**AGENDA
TECHNICAL REVIEW COMMITTEE (TRC)
August 5, 2025
10:00AM**

A. WaterVUE at Lake Geneva Major Site Plan– Alt Key 1284368

**RE: WATERVUE AT LAKE GENEVA (AVO 043866.165)
MAJOR SITE PLAN REVIEW #1**

I:\Data\22\MS\000-207 Spring Lake Road-Fruiiland Park\Eng\Final\2020 C100 Site Plan.dwg, May 14, 2023, 3:19 PM

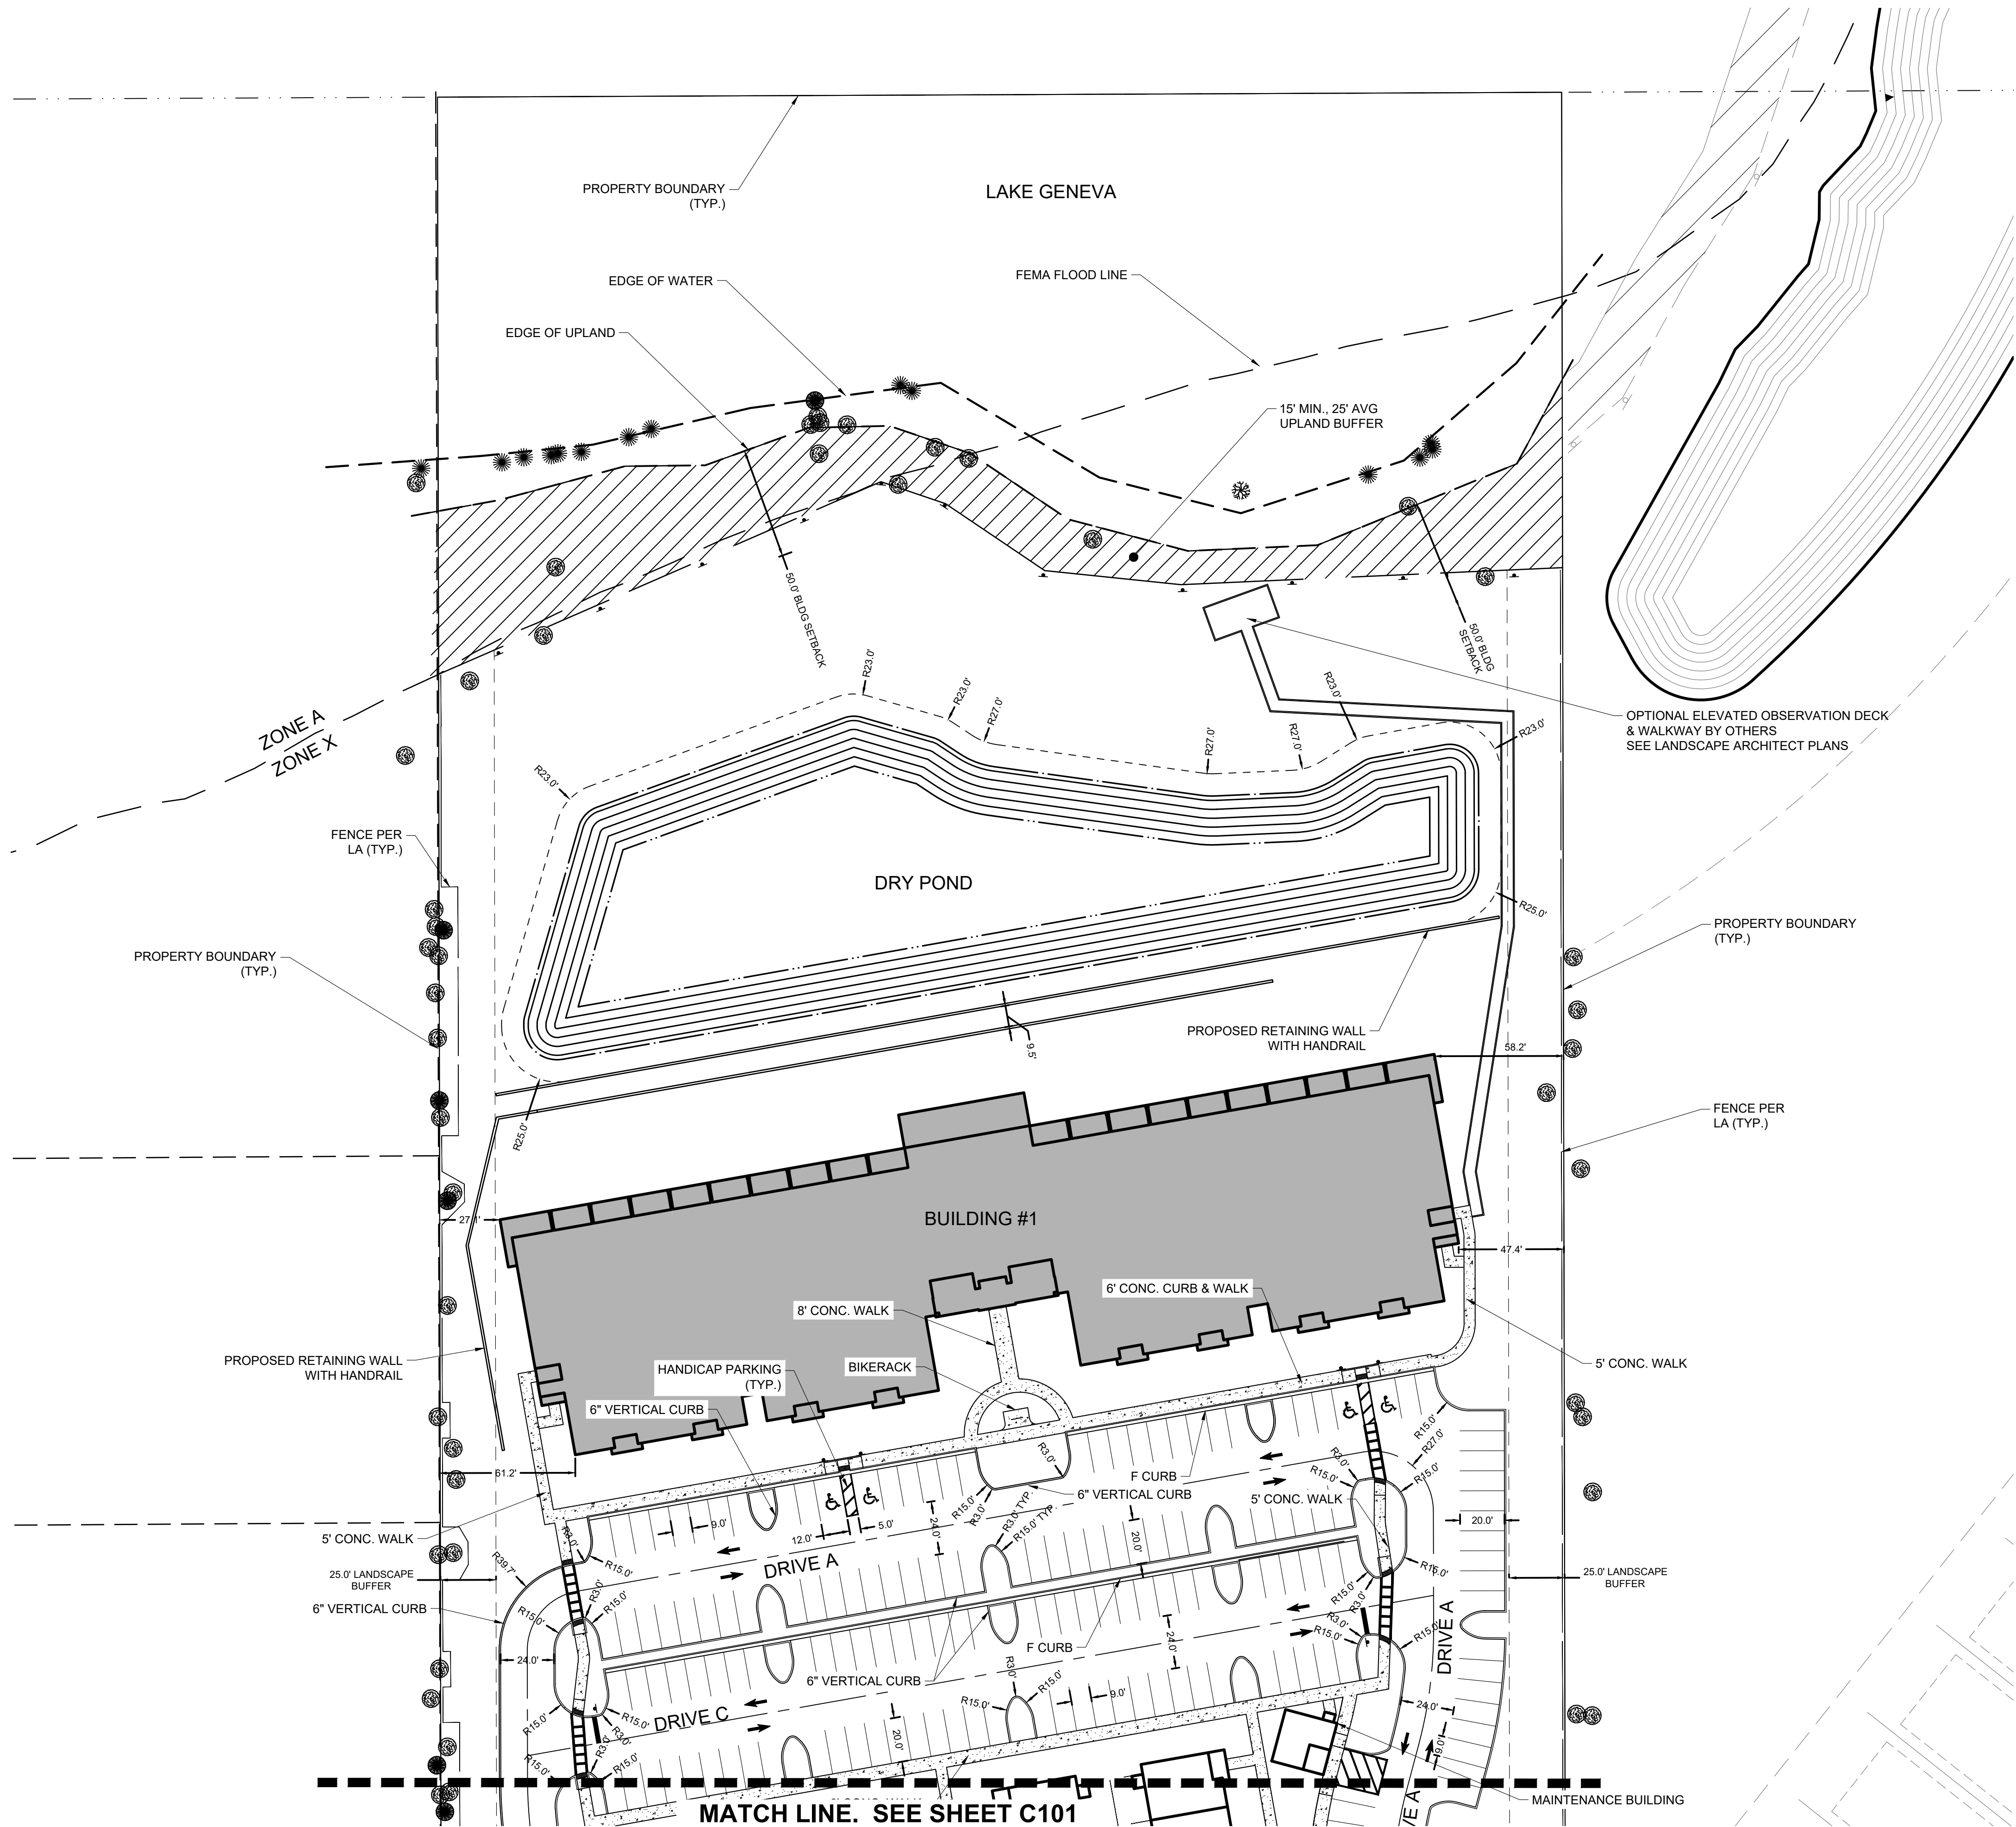
Comment 6: Sheet C05, C100 and C101 shows standard parking spaces as 9' x 20'. City standard space is 10' x 20' with 25% allowable for compact parking (9' x 18') (Chapter 162.060)

Response 6: The parking spaces have been left at their current 9'x20' size for this resubmission, we would like to discuss the dimensions at the upcoming TRC meeting.

C005

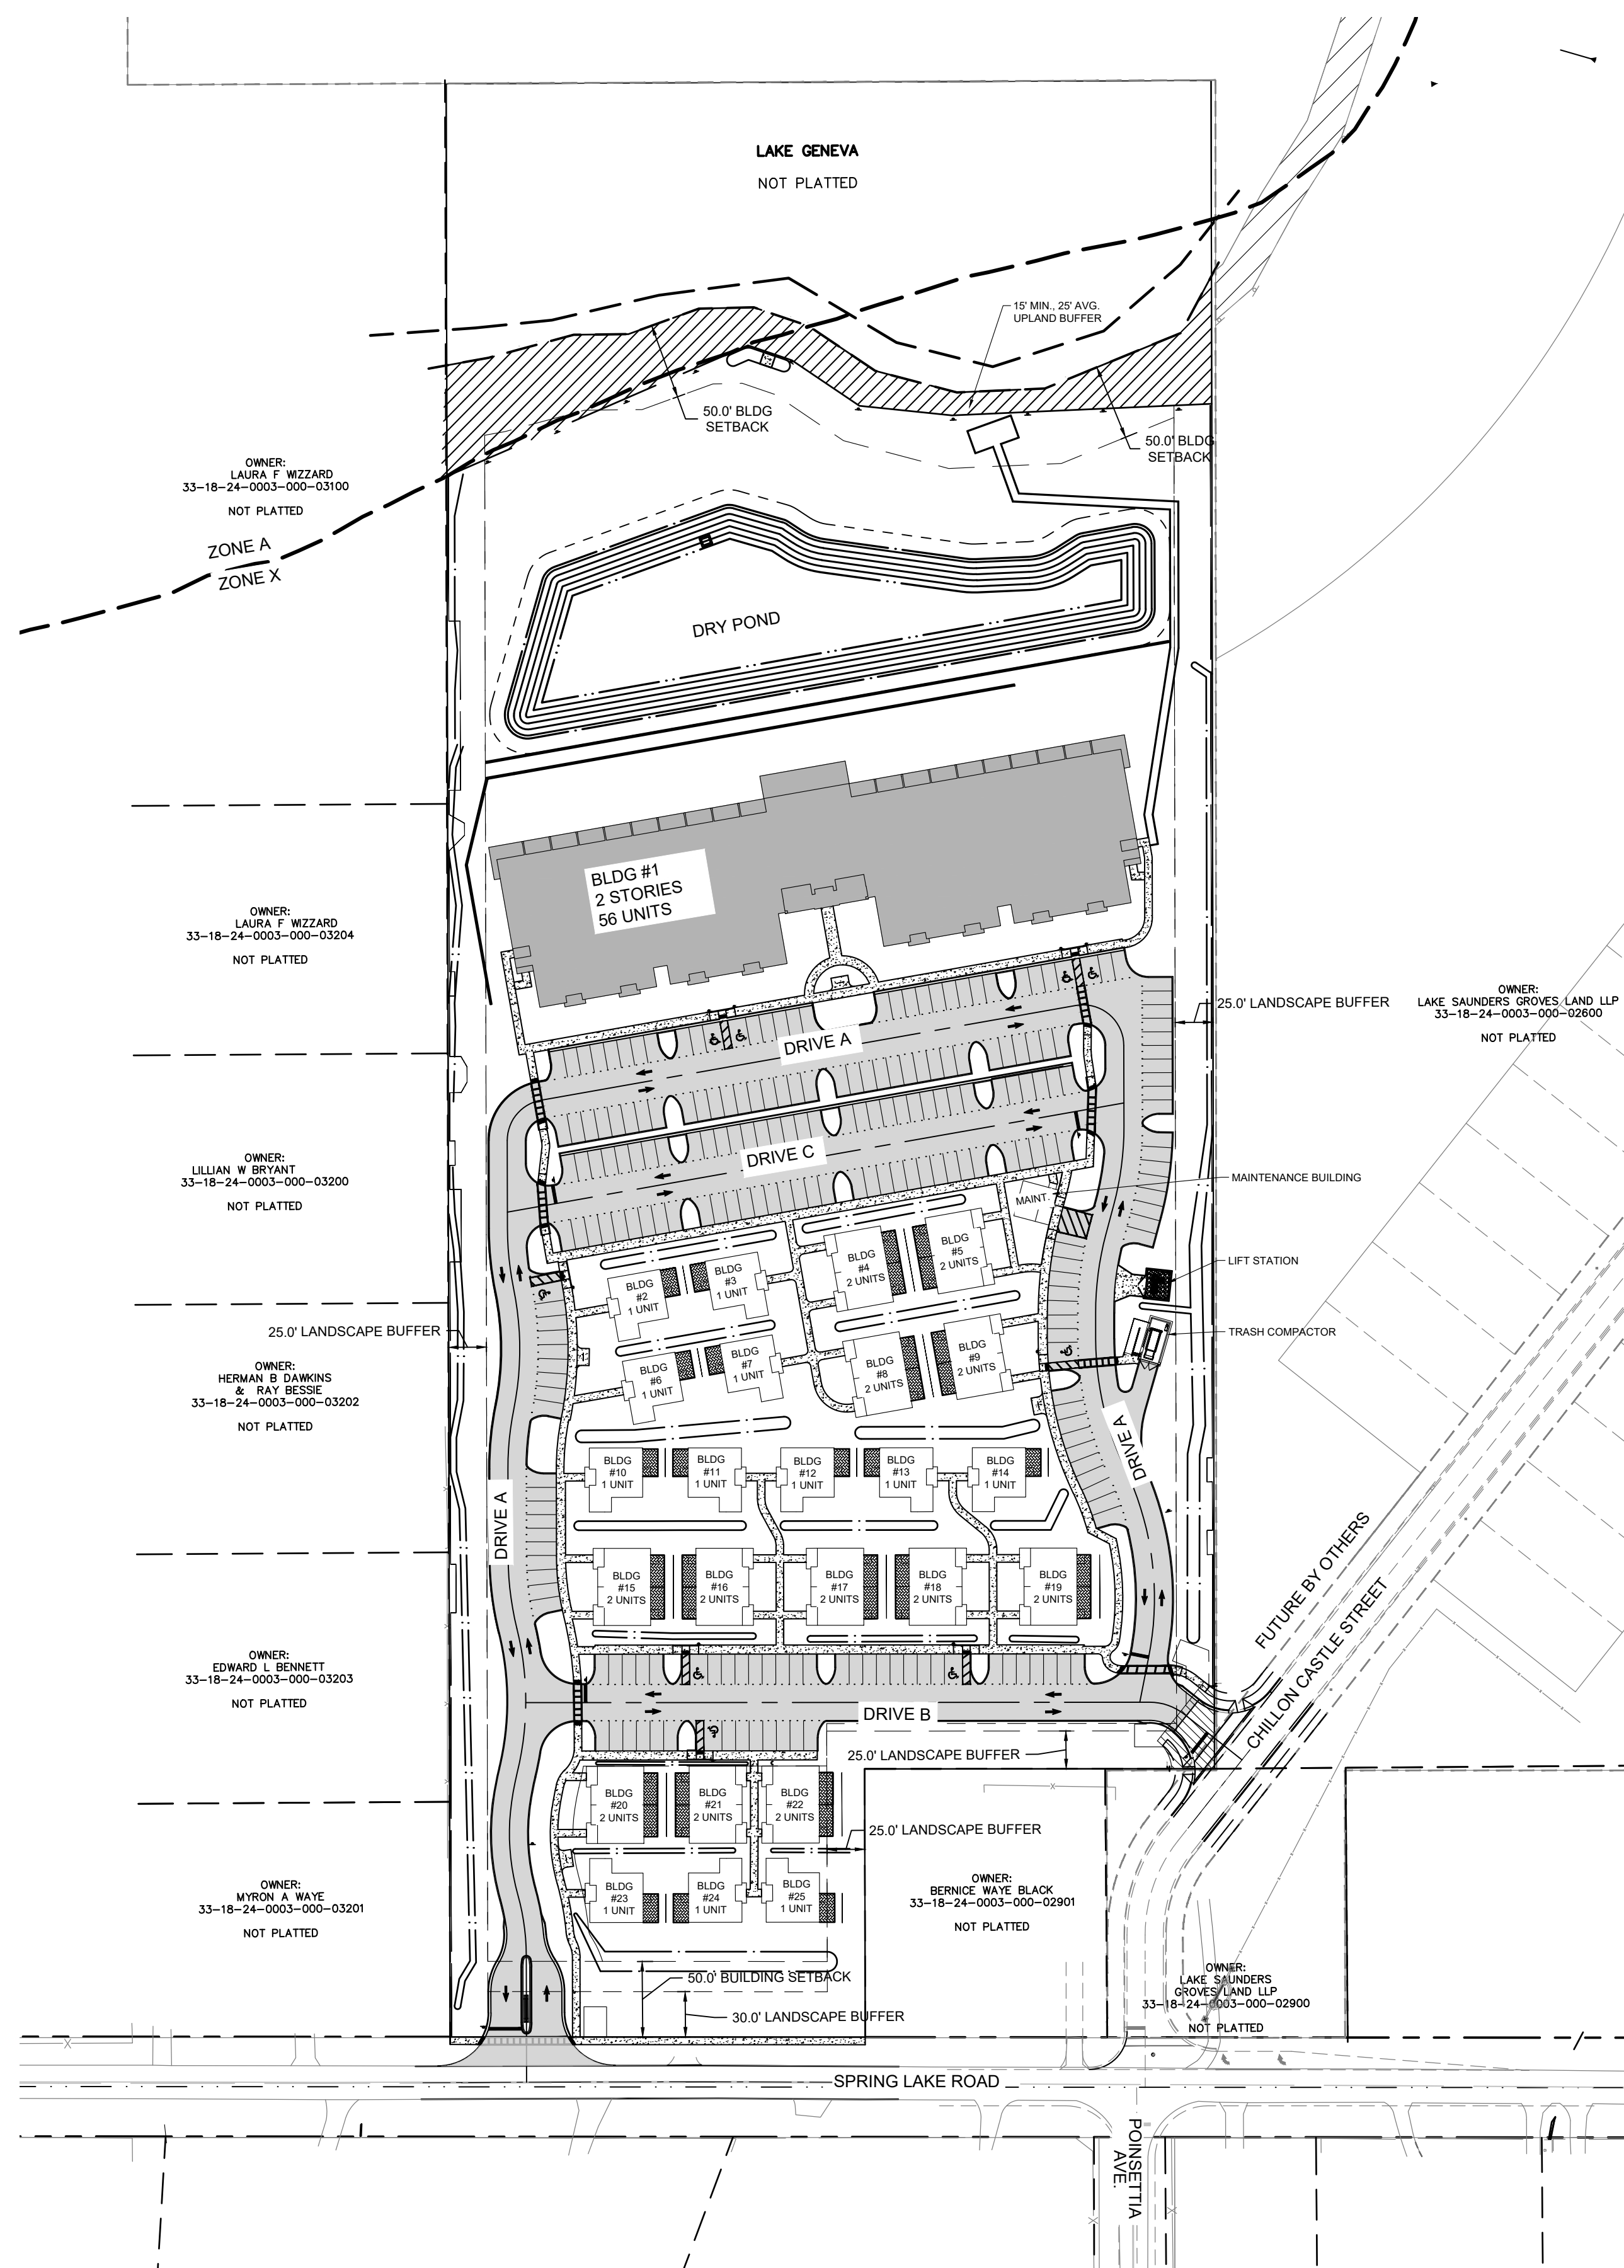
Comment 1: Sheet C05 note 8 calls the front landscape buffer out as 50-feet on Spring Lake Road, but in the plan view it is labeled as 30-feet. The PUD appears to state that 30-feet is required.

Comment 2: Sheet C05 note 9 calls the side building setback out as 50-feet. There are several buildings within 50-feet of the side property line. Section 6 of the PUD calls out that the side setback is 25-feet. Please clarify.

Comment 11: It appears that all internal drives will be privately owned/maintained. If this is correct, add a note to this effect to the plans.

Comment 20: While called out in the landscape plan, the site plan does not show the calculation for bicycle parking, or show/callout the location of the bicycle parking.

Response 1: The Landscape Buffer section of the overall site plan has been reviewed and modified based on the PUD. Please see the revised sheet C005.

Response 2: The building setback section of the overall site plan has been reviewed and modified based on the PUD. Please see the revised sheet C005.

Response 11: Internal drives will be privately owned and maintained. Note #14 of the overall site plan has been expanded on to mention this specifically. Please see the revised sheet C005.

Response 20: Calculations for the required and provided bicycle parking have been added to the overall site plan. Please see the revised sheet C005.
